FAQ Number 17-0013 **FAQ Revision** 0 (Draft ~~BC~~)
FAQ Title High Energy Arcing Fault (HEAF) Non-Suppression Probability (NSP)

Plant: Various Date: ~~March 21, 2017~~ January 18, 2018
Contact: Beth Meade Phone: (508) 532-7139
Mark Schairer (508) 532-7317
Mark Humphrey (508) 532-7269
Email: bah@epm-inc.com
mvs@epm-inc.com
msh@epm-inc.com

This FAQ provides an update to the non-suppression probability (NSP) for high energy arcing fault (HEAF) fires based on a review of additional fire event data.

Figure 5-2
Non-suppression curve plots: probability vs. time to suppression

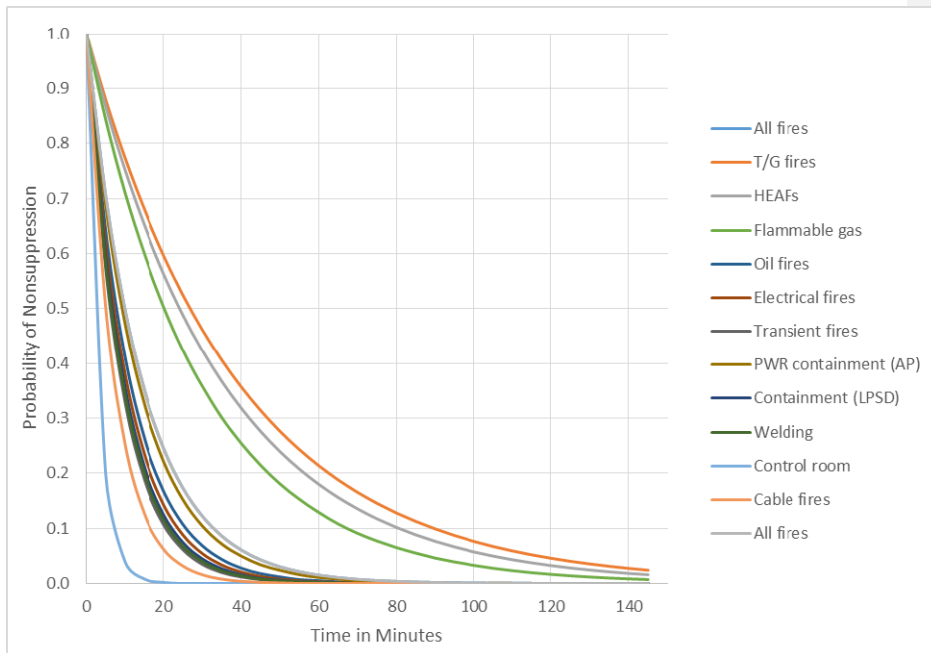
The re-binning of Fire Events #792 and #922 as HEAF fires versus electrical fires for the non-suppression probability necessarily results in a revision to the electrical fire non-suppression probability. The changes are reflected in the proposed revisions to NUREG-2169 included as part of this FAQ.

The following are proposed revisions to NUREG 2169:
